VHB
 Job Number: 57438
 Reviewed By: KZS
 Date: 3/18/2014

BRIDGE RAIL DETAILS SHEET

TOWN OF MIDDLEBURY, ADDISON COUNTY, VT RTE 125 (MAJOR COLLECTOR), BRIDGE NO. 13		EM13-252 MIDDLEBURY RS 0174 (B)	
R.NO.	DATE	BY	NO.
E		E	
V		V	
DRAWN		E.P.	
CHECKED		D.L.	
APPROVED		3/10/14	
SCALE		SCHEMATIC	
DRAWING NO. FRL - MIDDLEBURY

Calvanized 2-Rail Bar Beam Guardrail Approach Section

BILL OF MATERIALS, WW 1

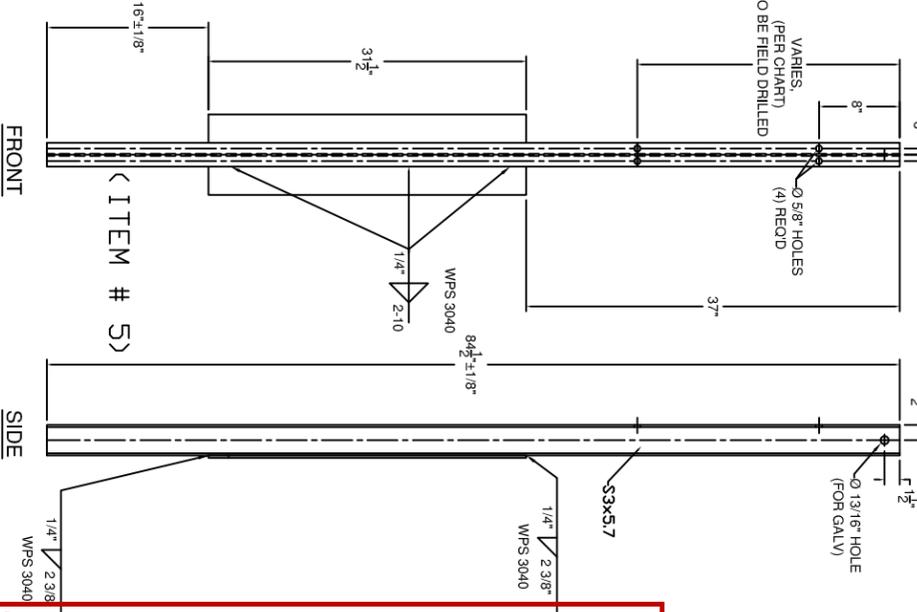
Confirm member size

SPLICE TUBE - FIXED

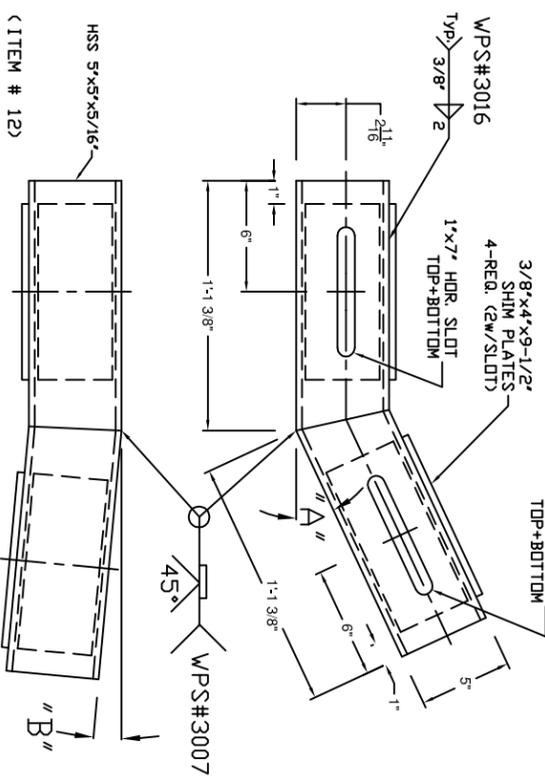
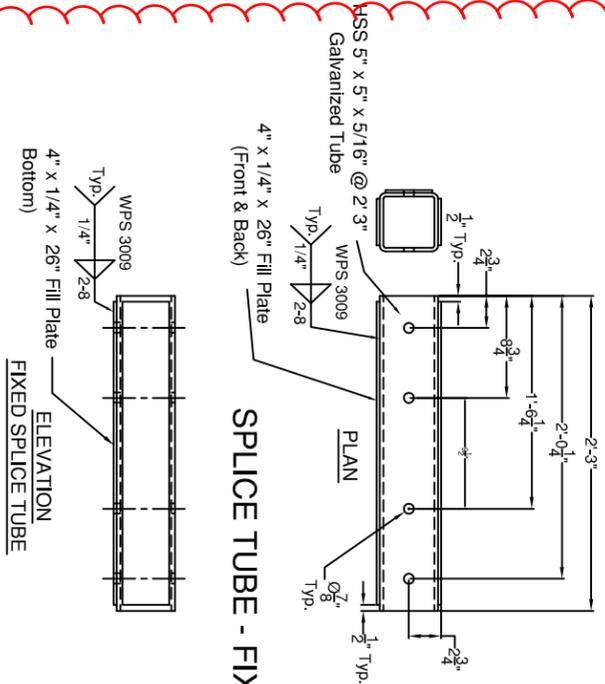
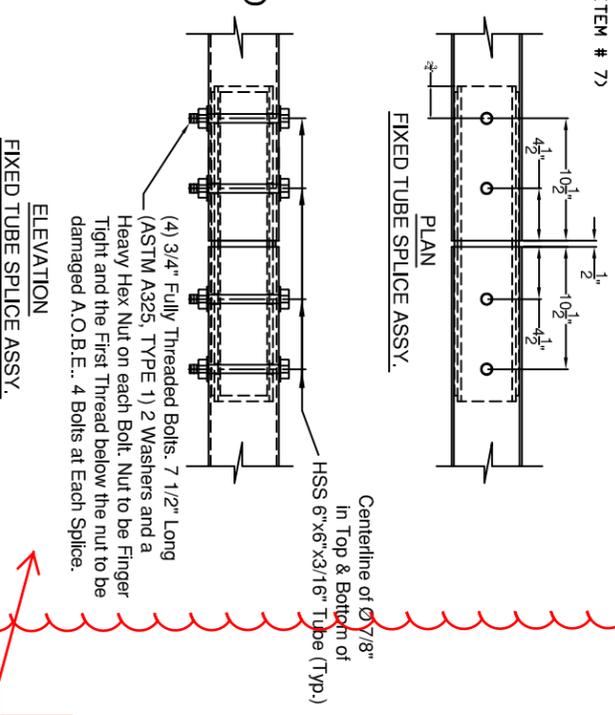
Revise splice connection to match Standard G-1b

GUARD RAIL TO BRIDGE RAIL TRANSITION WW2 & WW3

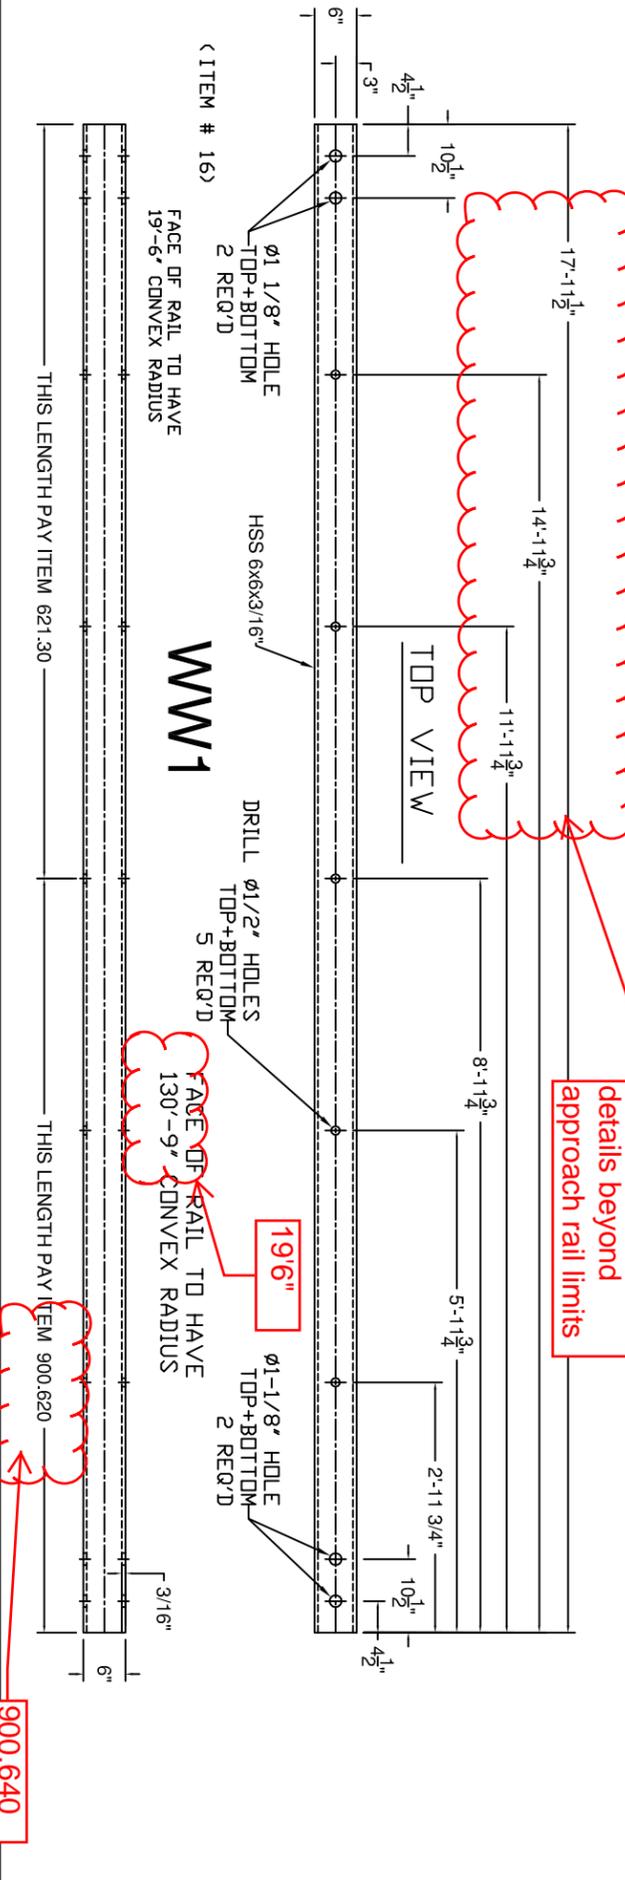
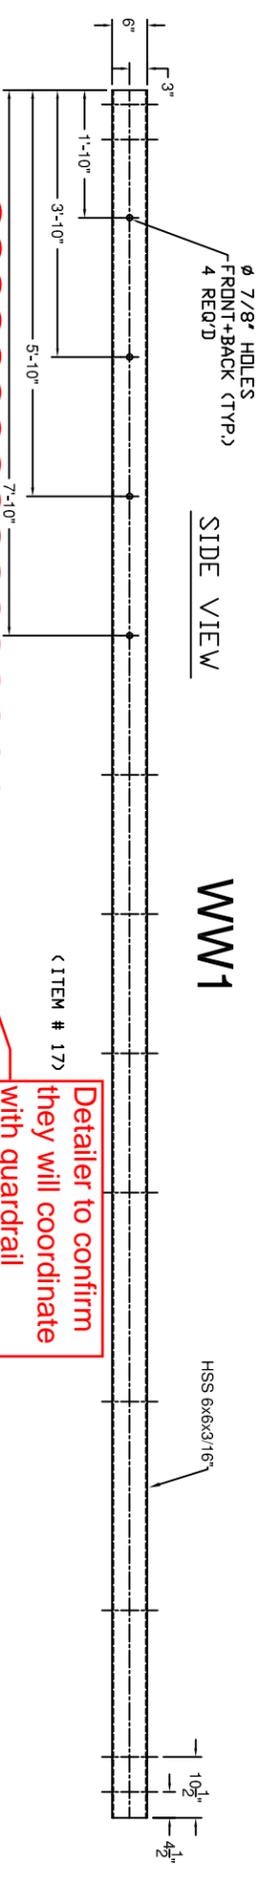
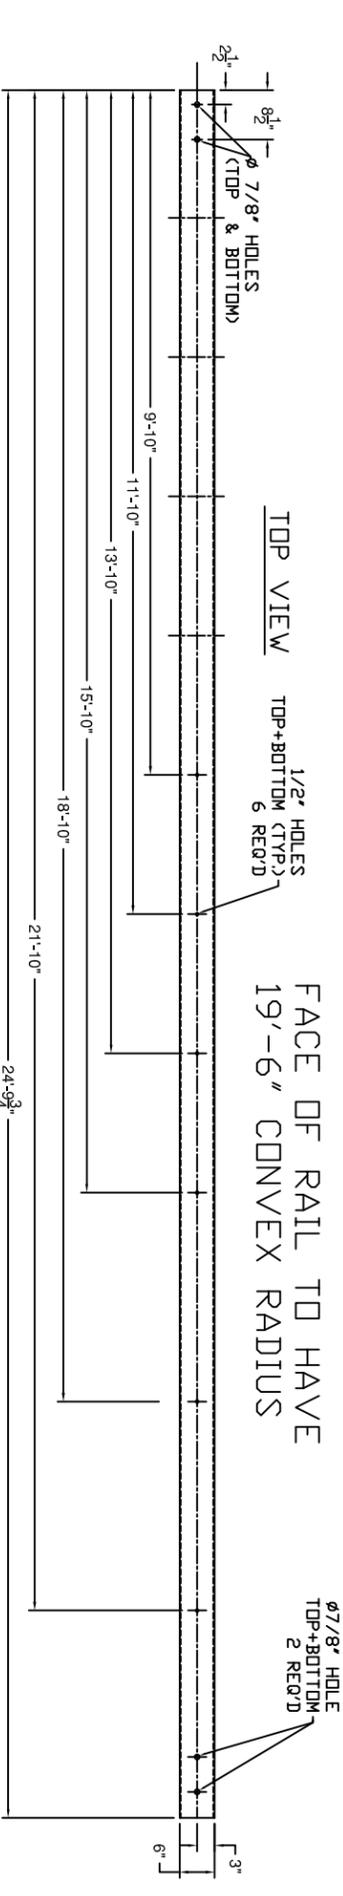
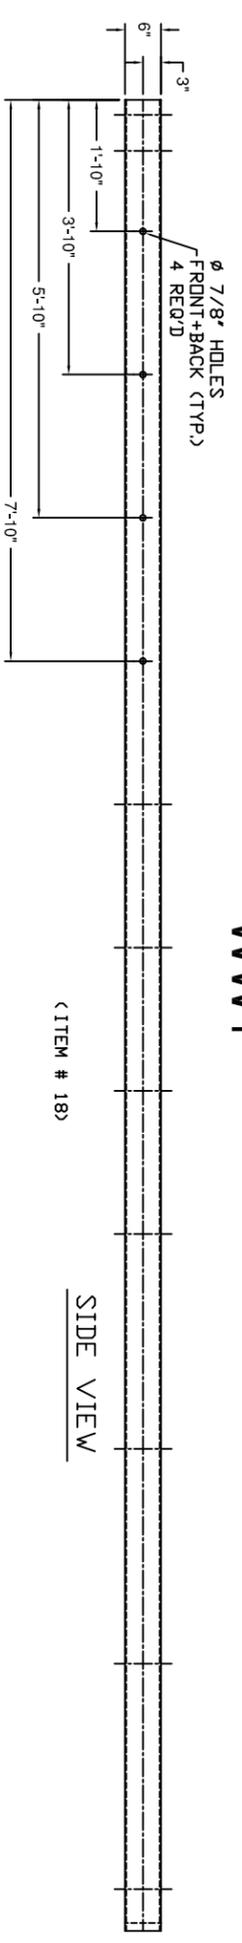
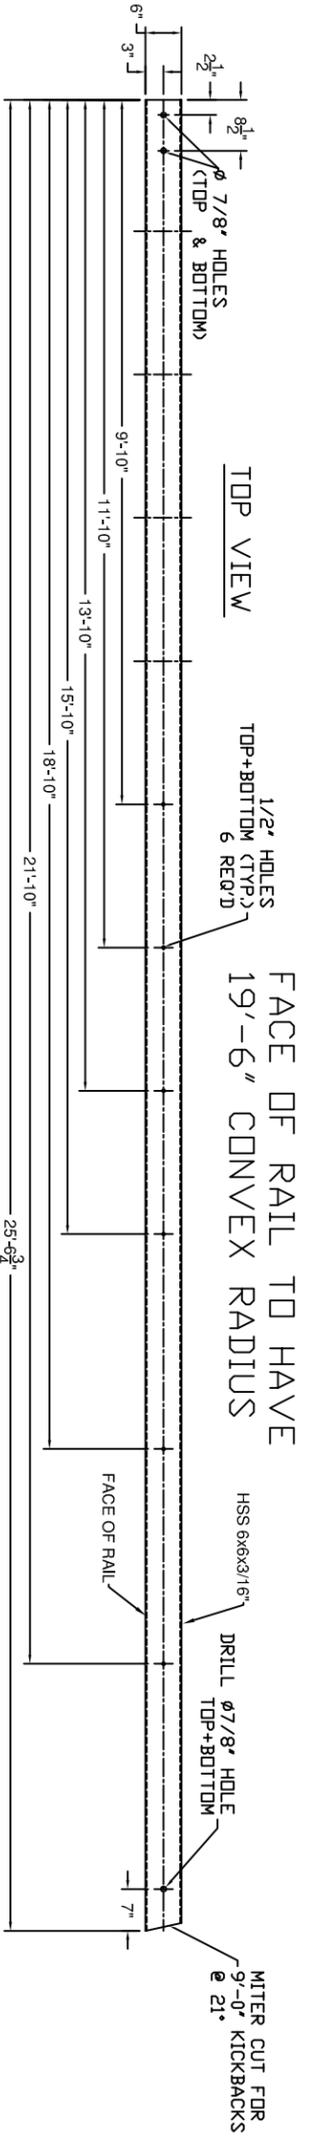
Detailer to confirm they will coordinate with guardrail details beyond approach rail limits

BILL OF MATERIALS, WV 2

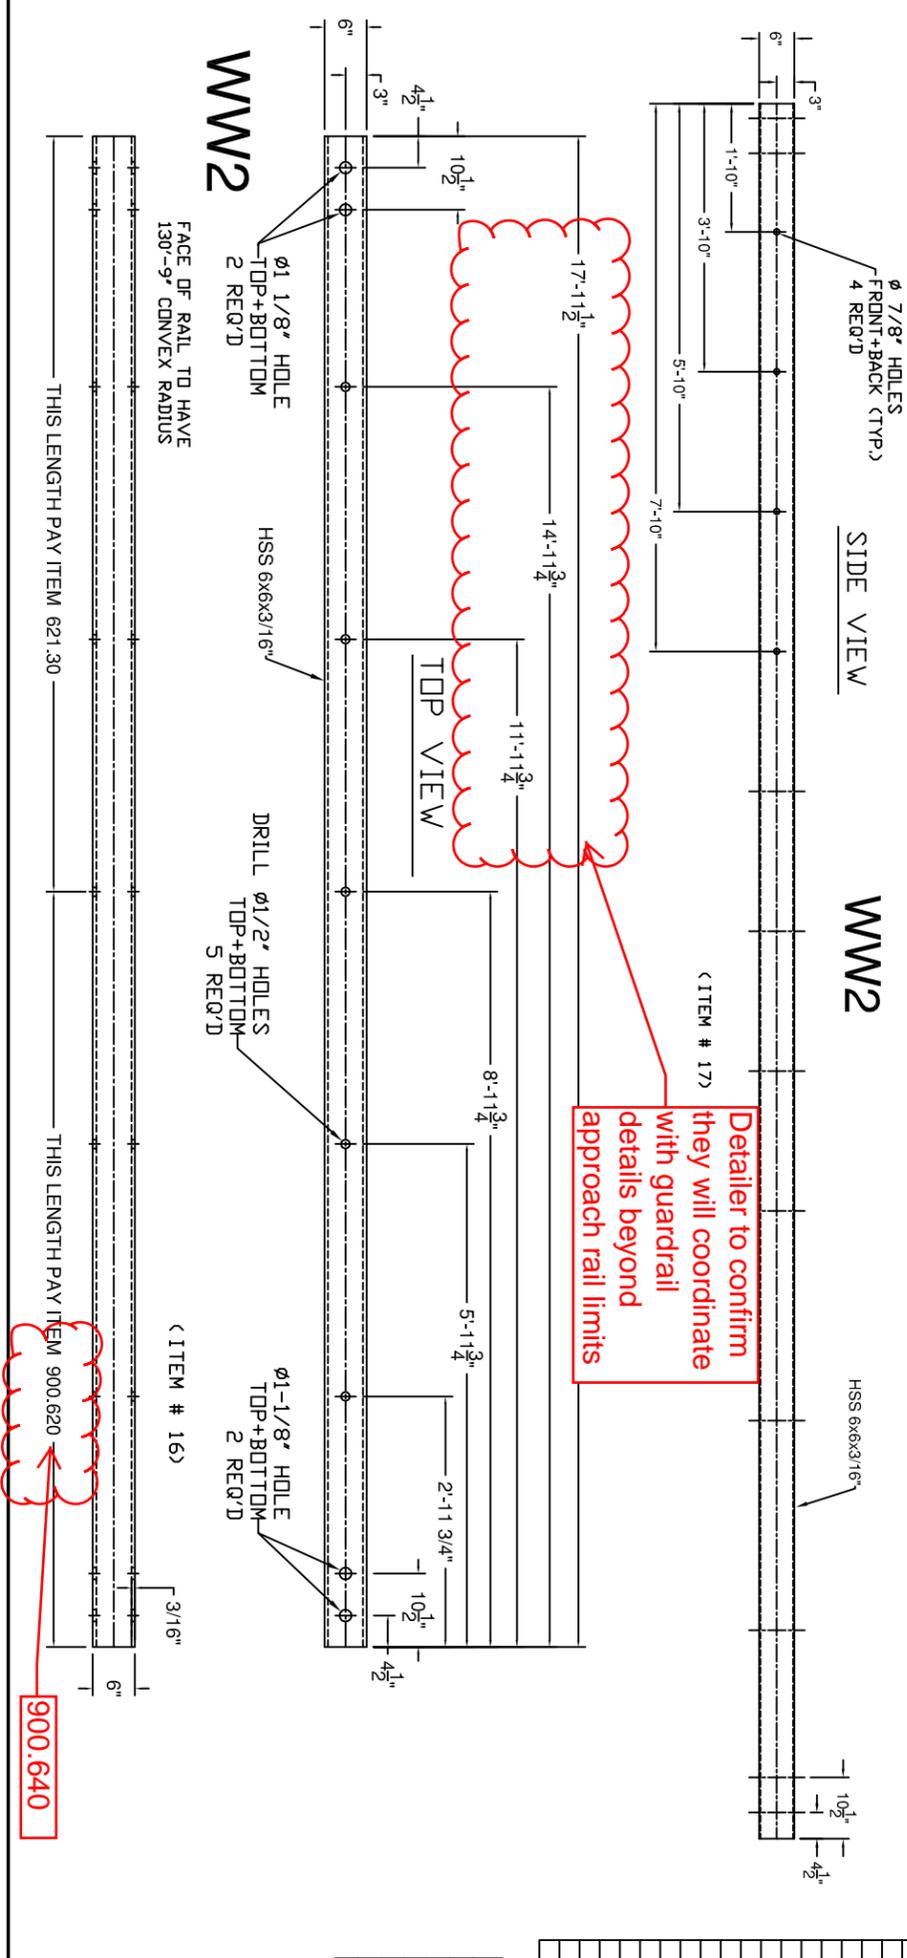
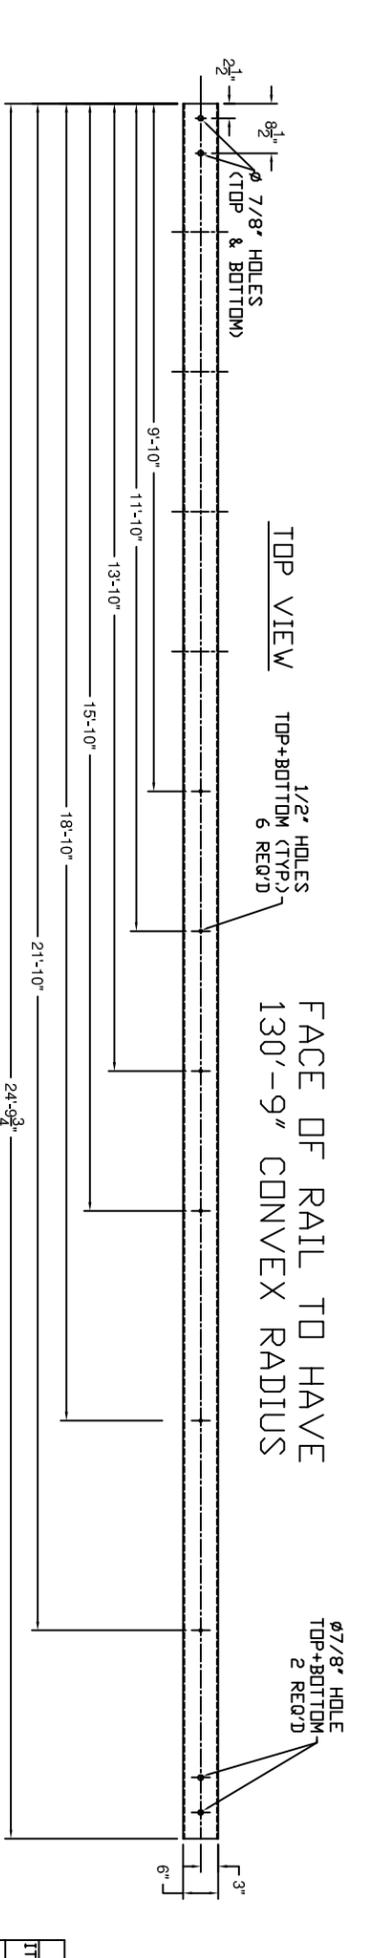
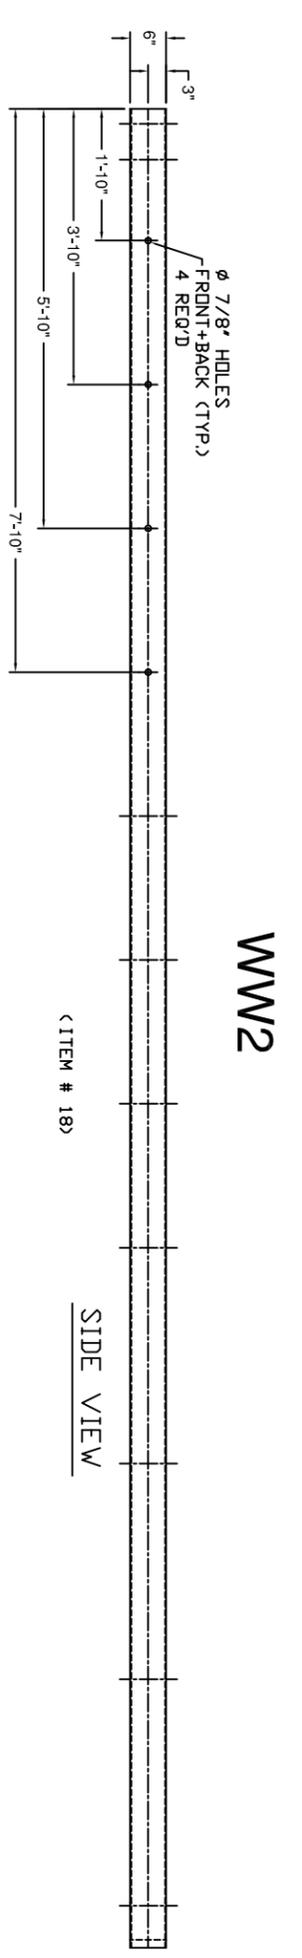
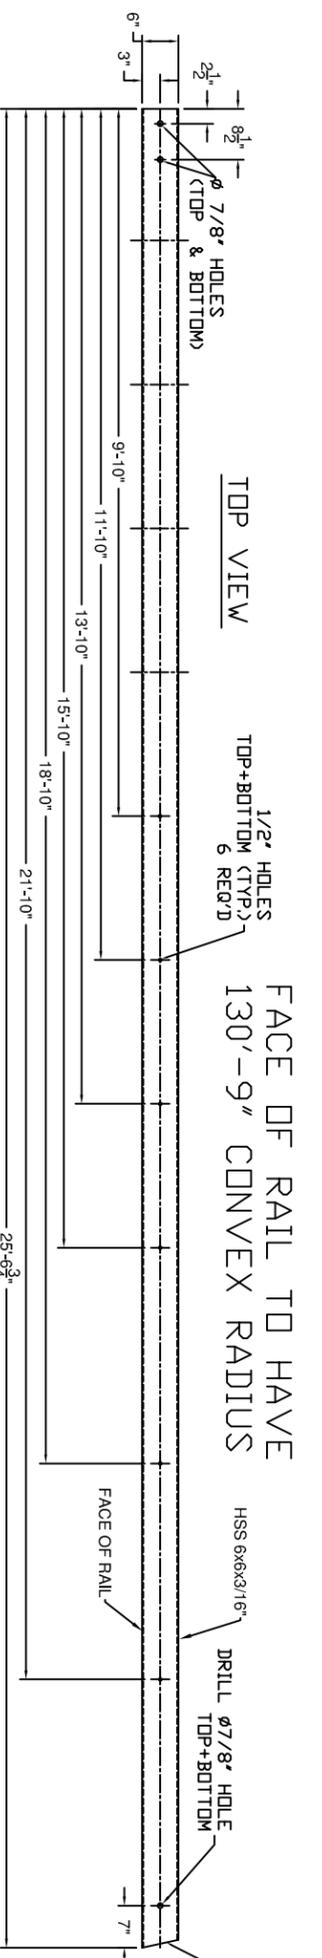
Detailer to confirm they will coordinate with guardrail details beyond approach rail limits

confirm member size
